UNITED STATES PATENT AND TRADEMARK OFFICE

10/523,972

Office Action Summary	Application No. 10/523,972	Applicant(s) KADOUCHI ET AL.	
	Examiner SAMUEL BERHANU	Art Unit 2838

Fig. 44

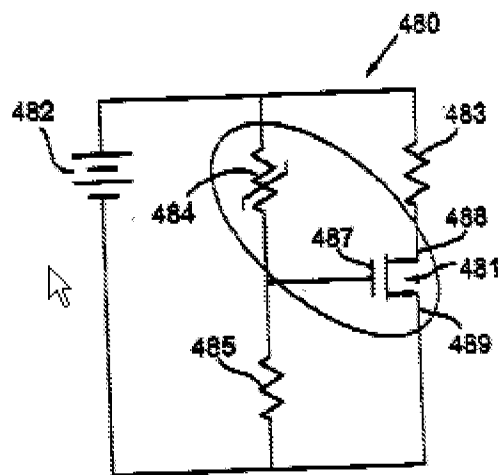
Thomas discloses in Figure 44, and paragraph 0193, a heating resistor increases automatically so that heat generating current stops and the independent discharge circuit is electrically connected to the battery (see below)

[0193] In accordance with this aspect of the inventions disclosed, PTC device 484 is thermally coupled to the FET device 481 as a protection against failure of the FET device 481 in case of overvoltage from battery 482. As the voltage across the PTC device 484 and, thus, across device 481, approaches a level that might otherwise cause the FET device 481 to fail, current flowing through the PTC device 484 will sufficiently heat the device 484 to its trip temperature. Once PTC device 484 trips to its high resistance state, the voltage across the device 484 will immediately drop to a level below the threshold gate voltage of the FET device 481, causing the FET device 481 to turn OFF.

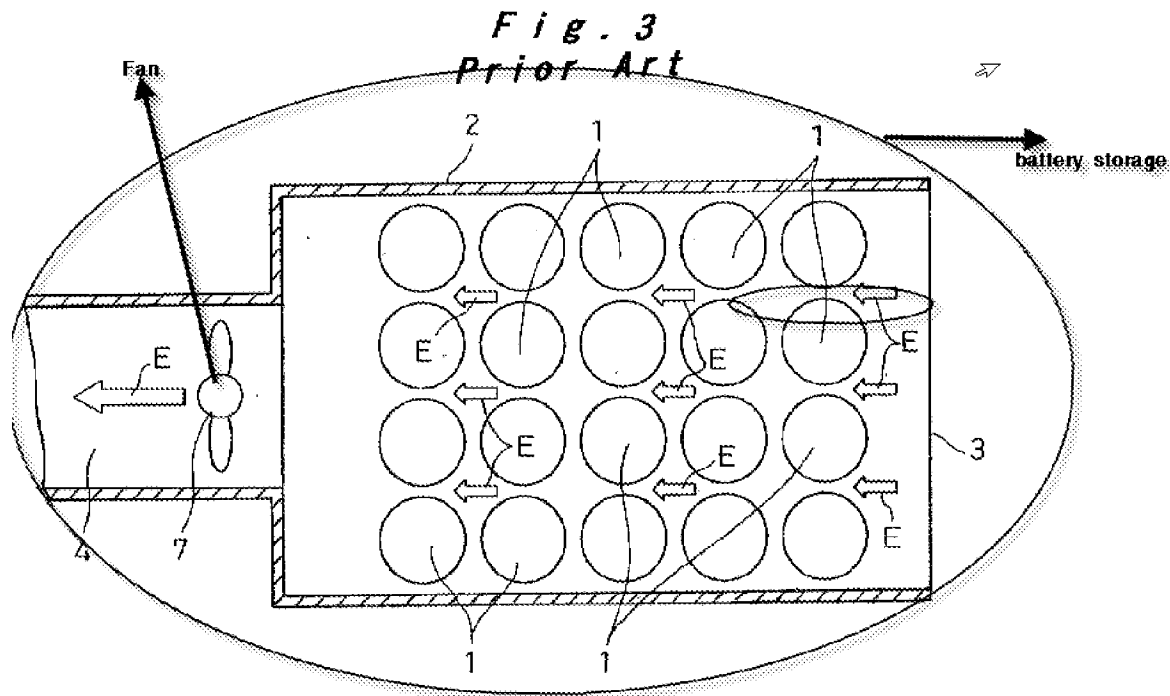
As to Claim 14, Oshida discloses in Figure 22, a plurality of heat conducting fins (152), a heat conducting body (154) located at said opening for conducting heat between said plurality of fins, wherein said hear conducting fins communicate with said heat conducting body.

Oshida discloses in Figure 22, a plurality of heat conducting fins (152), a heat conducting body (154) located at said opening for conducting heat between said plurality of fins, wherein said heat conducting fins communicate with said heat conducting body.
